LEGAL NOTICE EXETER PLANNING BOARD AGENDA

Date: August 11, 2021
To: Planning Board
From: Dave Sharples, Town Planner
Re: One Home Builders LLC PB Case #21-6

Re: Site Plan Review TRC Comments - One Home Builders LLC
PB Case #21-6
Tax Map Parcel #82-36

TITLE: 109' REAR MOUNT LADDER TURNING RADIUS REPORT
 DRAWN BY: ZCZ DATE: 17SEP 3 MATERIAL: SEE BILL OF MATERIAL

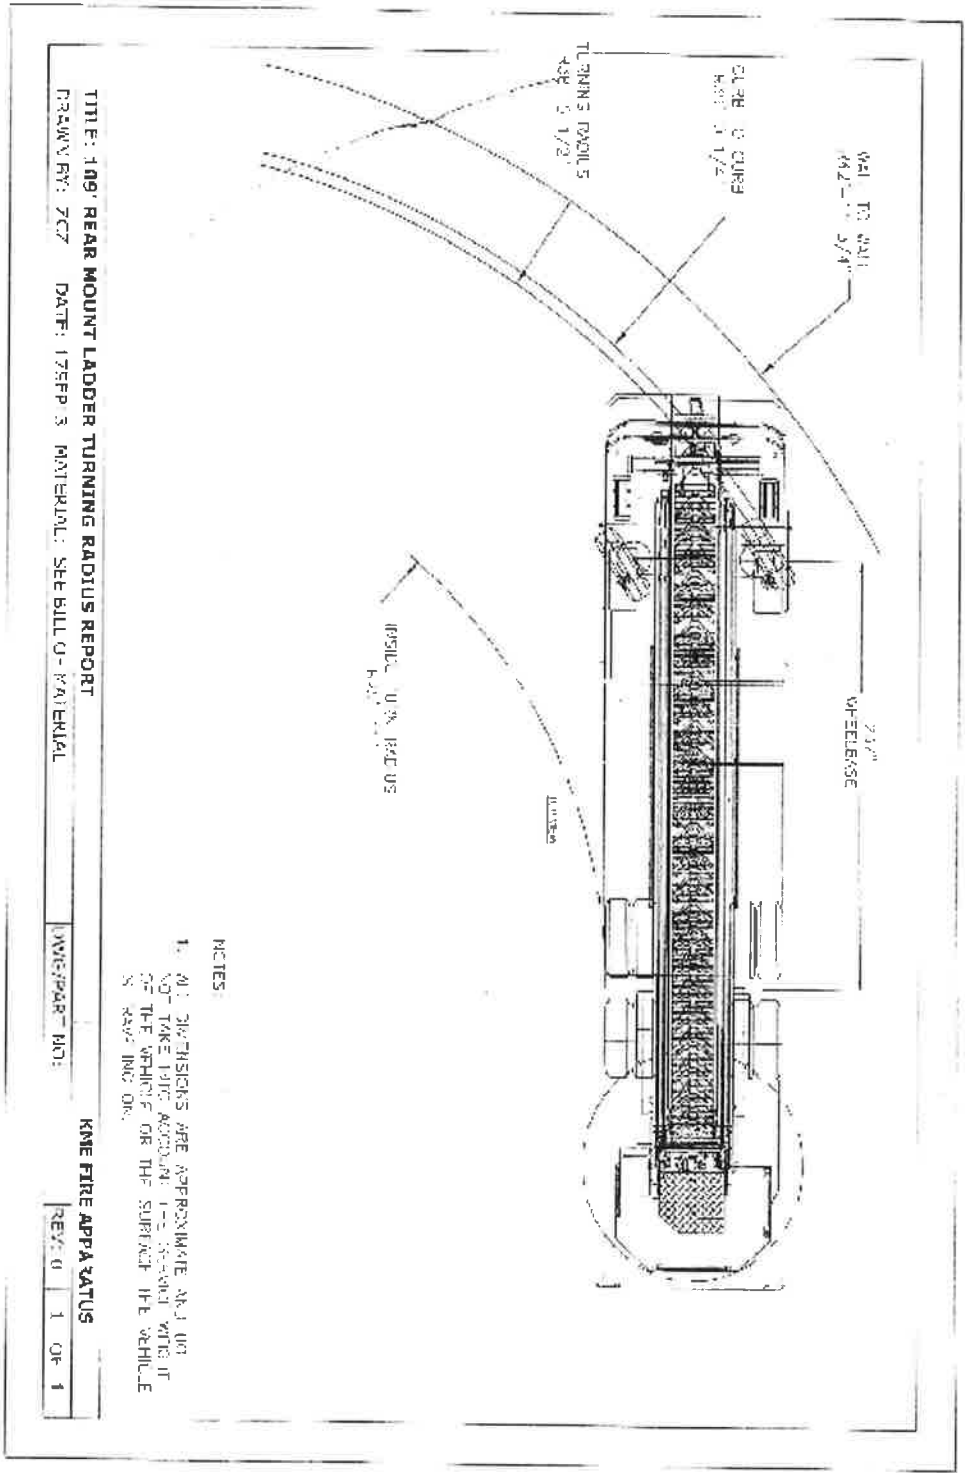
13. **Turning Movements:** Please clarify the turning movements for garbage trucks, delivery vehicles, moving vans, etc.
14. **Fire Truck Accessibility:** Please clarify the fire ladder truck turning movements. The plans should be reviewed by the Exeter Fire Department for confirmation of accessibility and fire truck turning movements.

EXETER LADDER TRUCK TURNING
EXHIBIT
scale - 1" = 40'

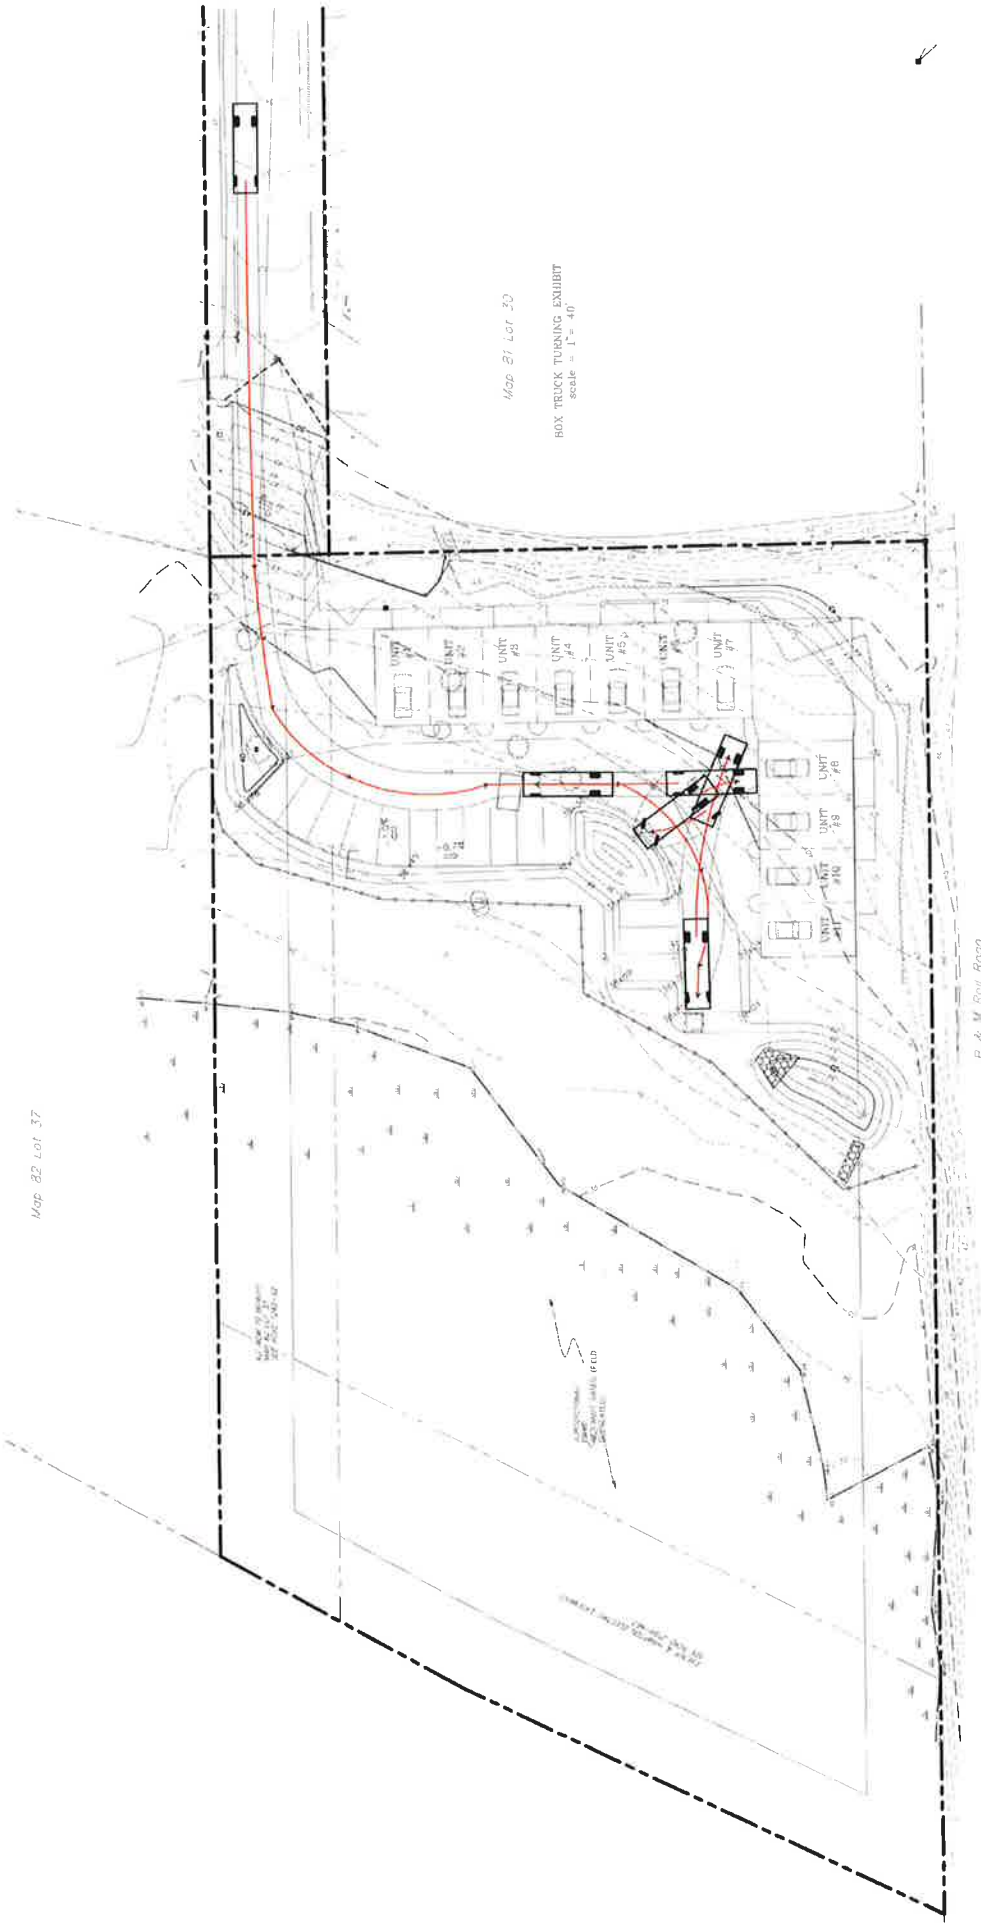
16. Confirm these are all 2-bedroom units and provide floor plan;
17. Traffic impact memo. Have traffic engineer call me at 773-6114 to discuss;
18. I am concerned about the lack of a turn around onsite or on Charter St for plows, public safety, etc. since we are introducing ten more units to the end of the street. Please address this concern; and,
19. Provide copy of recorded easements;
